Product/Process Change Notice (PCN)

PCN #:
PCN_WE_RJ45LAN_20160823_7499XXX

Product Affected: WE-RJ45 LAN

OLD:

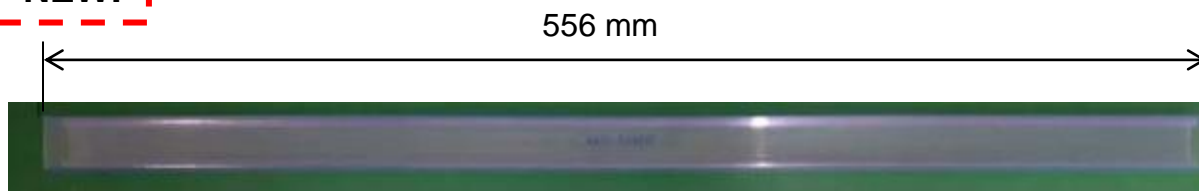
The current tube material polystyrene (PS), is changing into polyvinyl chloride (PVC).

The tube length will be increased from 540 mm to 556 mm.
